Serial No. : 09/771,229

Title : **CLOCK PHASE DETECTING CIRCUIT AND CLOCK
REGENERATING CIRCUIT EACH ARRANGED IN
RECEIVING UNIT OF MULTIPLEX RADIO EQUIPMENT**

PETITION UNDER 37 CFR 1.181(A)
REQUESTING
WITHDRAWAL OF HOLDING OF ABANDONMENT

AMENDMENT UNDER 37 C.F.R. § 1.173(b)

FIG. 14

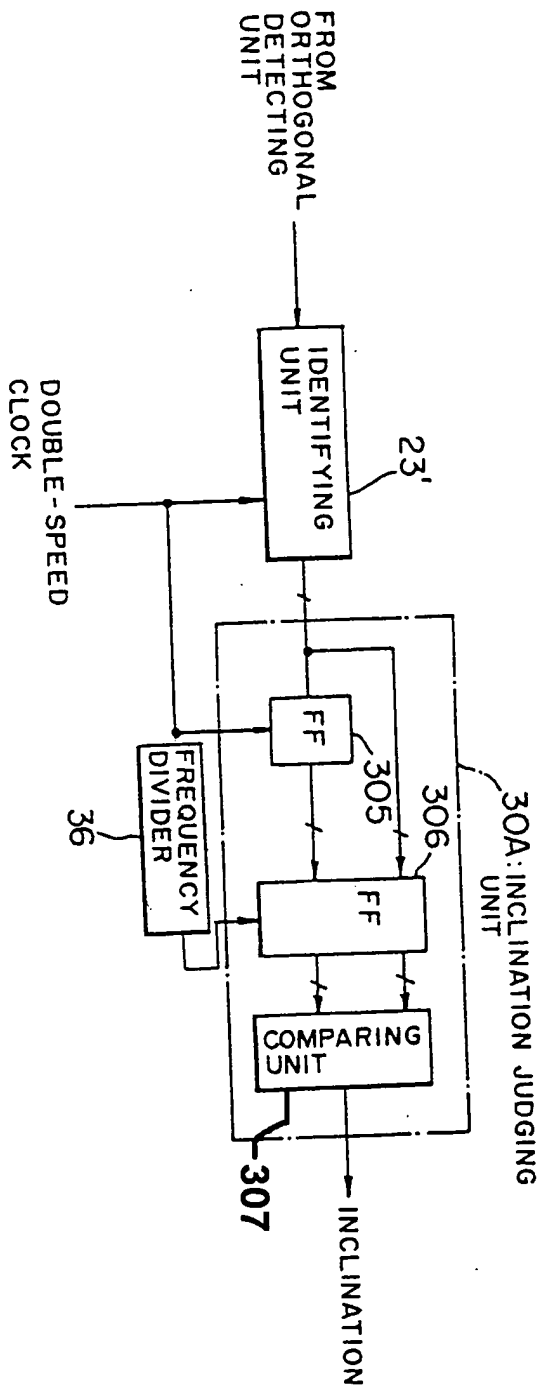
FIG. 14 objected to under 37 C.F.R. § 1.84(p)(5) for failing to include reference sign 307, which is mentioned in the specification at column 26, line 34. Applicants attach clean and marked-up versions of a proposed amended FIG. 14 to include reference sign

307. Accordingly, Applicants respectfully request approval of the proposed changes, and withdrawal of the drawing objection.
